Re: Former Chevron Service Station 95607
5269 Crow Canyon Road
Castro Valley, CA
ACEH Case #RO 0350

Re: Revised Drilling Scope of Work
Former Chevron Station 95607
5269 Crow Canyon Road
Castro Valley, California
Fuel Leak Case RO0350

Figure 2
 SITE PLAN
 FORMER CHEVRON STATION 95607
 5269 CROW CANYON ROAD
 Castro Valley, California

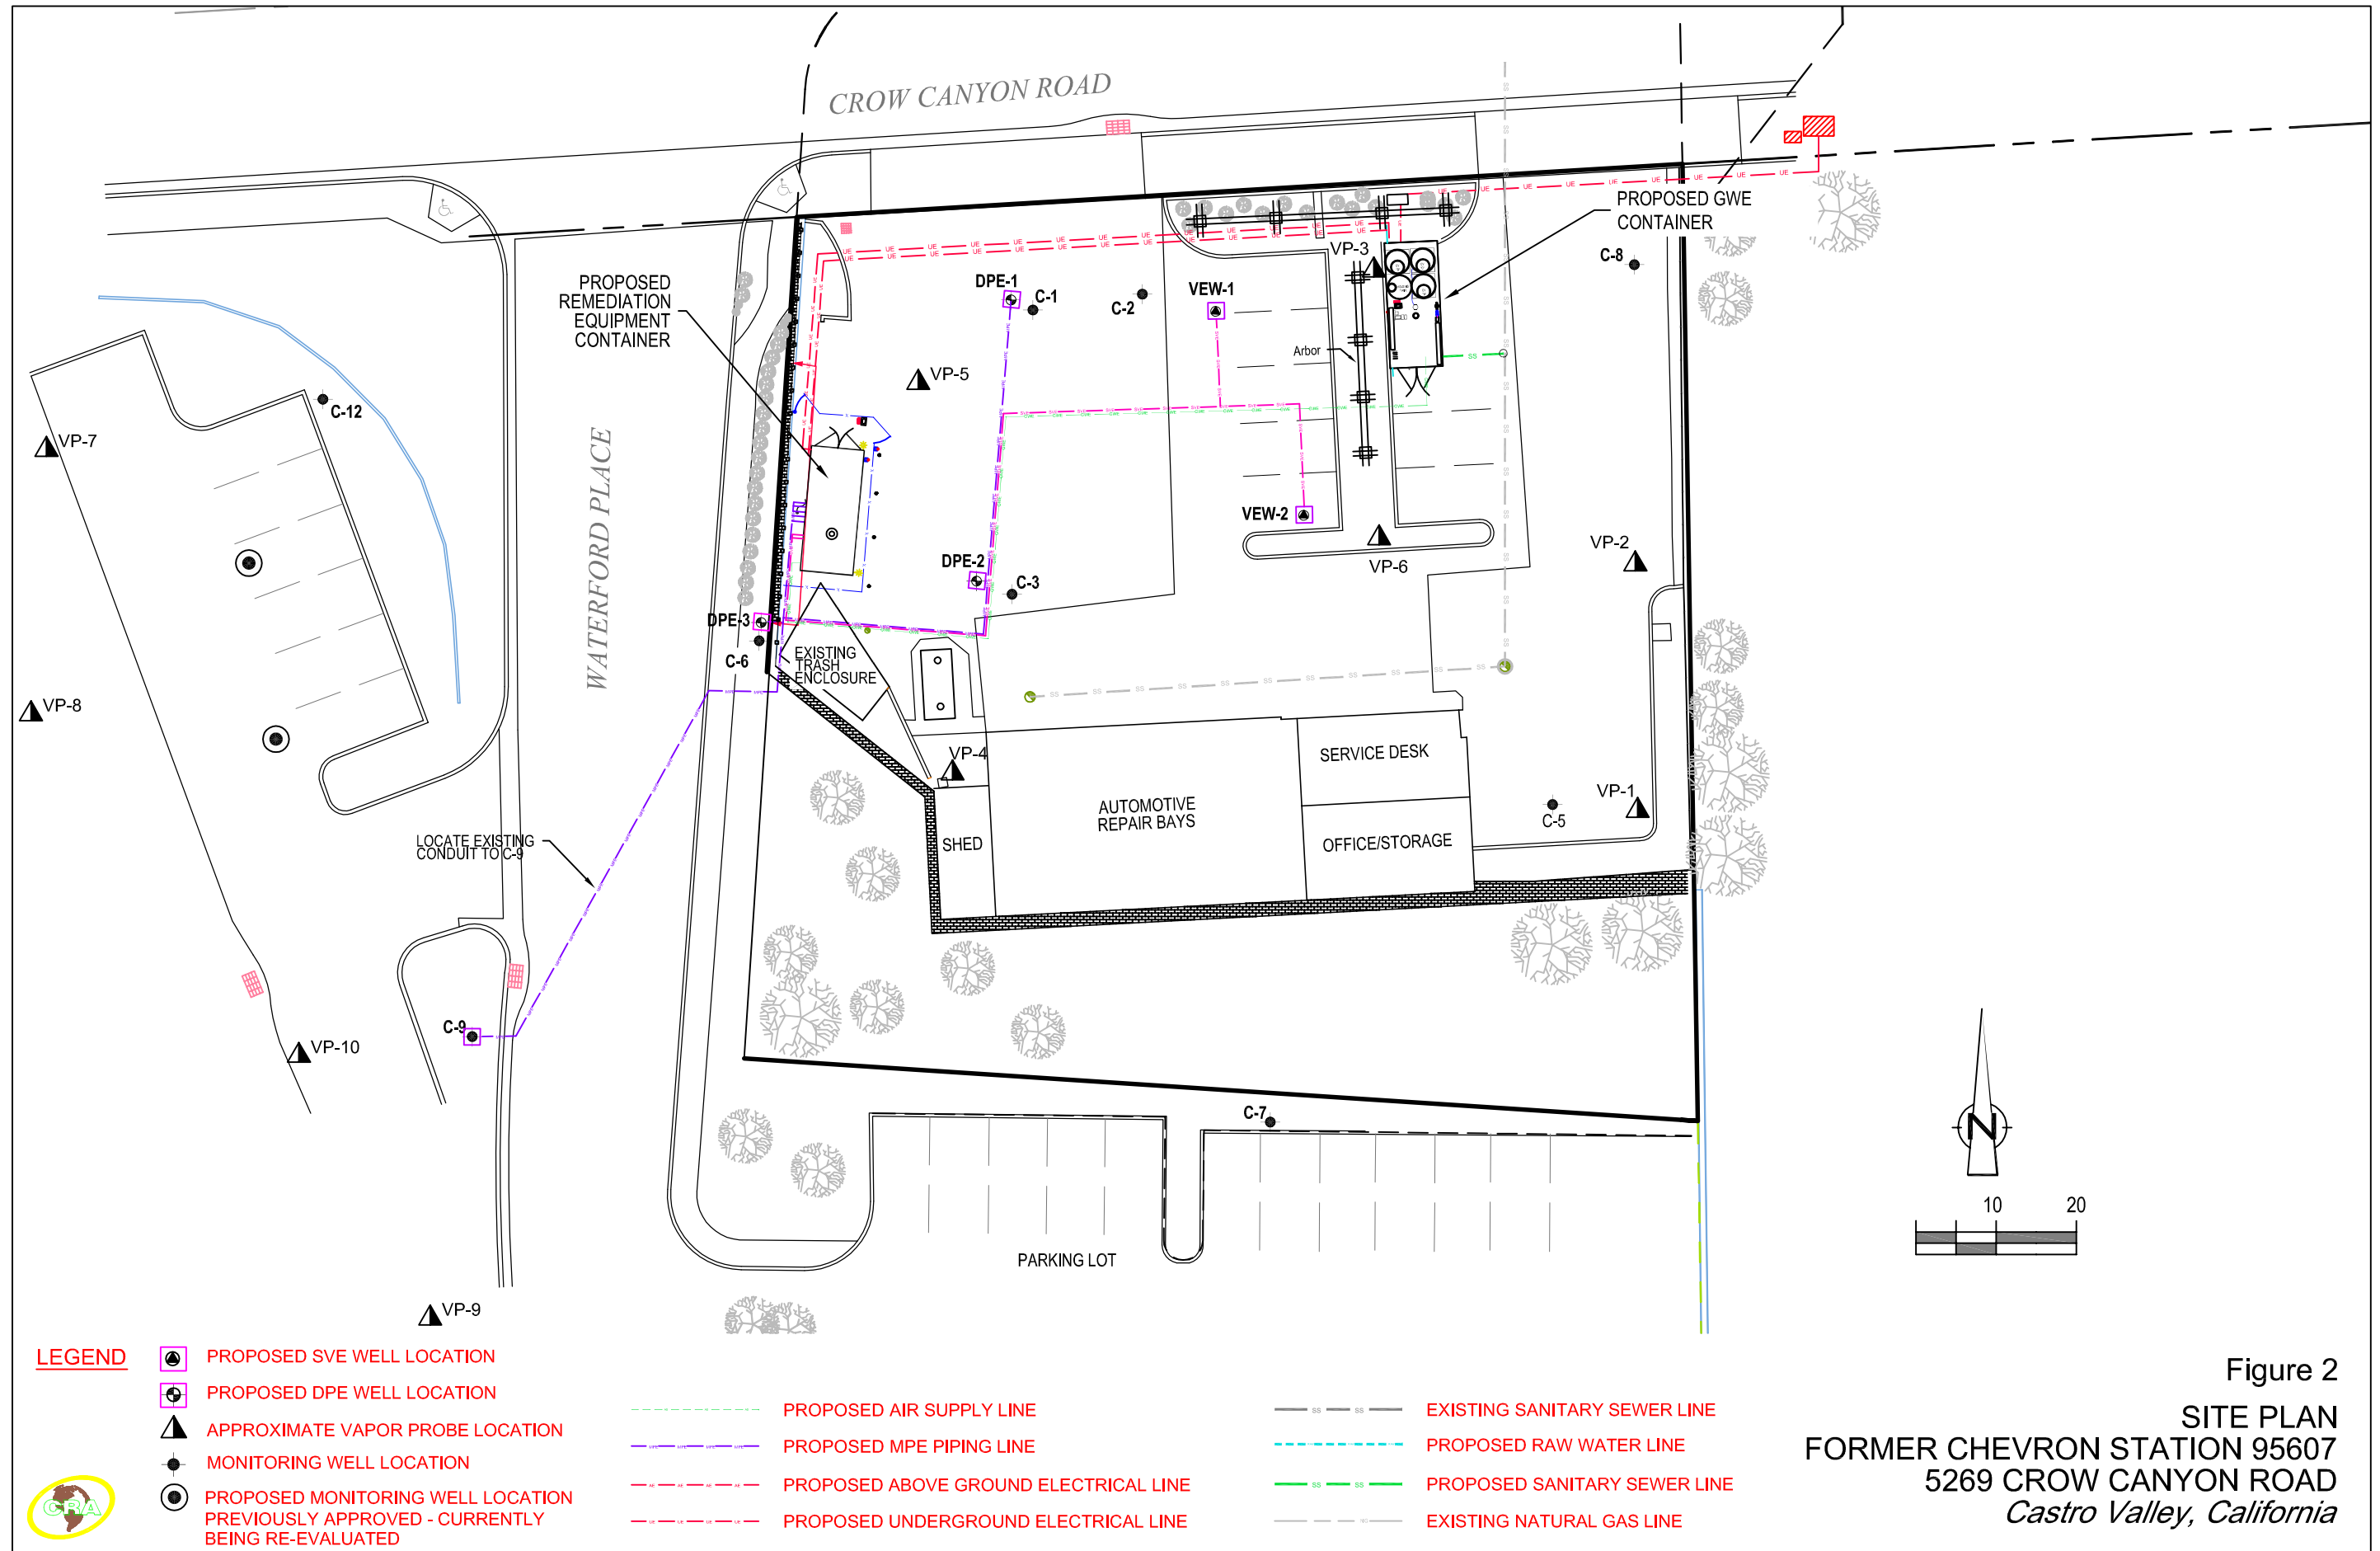
Revisions to the approved scope have been discussed with ACEH, most recently during a telephone call on October 23, 2013. During the call, CRA proposed the installation of two onsite soil vapor extraction (SVE) wells in the vicinity of the former dispenser islands, installation of an additional DPE well adjacent to well C-9, and elimination of one or both of the monitoring wells proposed between C-9 and C-12. The following sections provide further details of the proposed revisions to the drilling scope of work. The locations of the proposed wells are shown on the attached Figure 2.

Based on the results of the soil vapor assessment in the area of the former dispenser islands, CRA has added two SVE wells in that area (Figure 2) to be connected to the proposed DPE

During the call on October 23, 2013 with ACEH and Chevron, CRA proposed installing a DPE well near monitoring well C-9 located across Waterford Place. The construction details for well C-9 indicate that it was constructed using 4-inch diameter Schedule 40 PVC casing with 0.020-inch slotted screen. The well is screened from 5 to 30 fbg, with the bottom of the well sitting on bedrock. Based on the well construction details, CRA proposes using well C-9 as an extraction well in lieu of installing another well. During operation of the DPE system, monitoring and sampling of C-9 will continue. Just prior to each monitoring and sampling episode while the system is operating, the submersible pump installed in C-9 will be removed to allow for measurement of depth to water and collection of a groundwater sample. Immediately following each sampling event, the pump will be replaced in C-9 and extraction will be resumed.
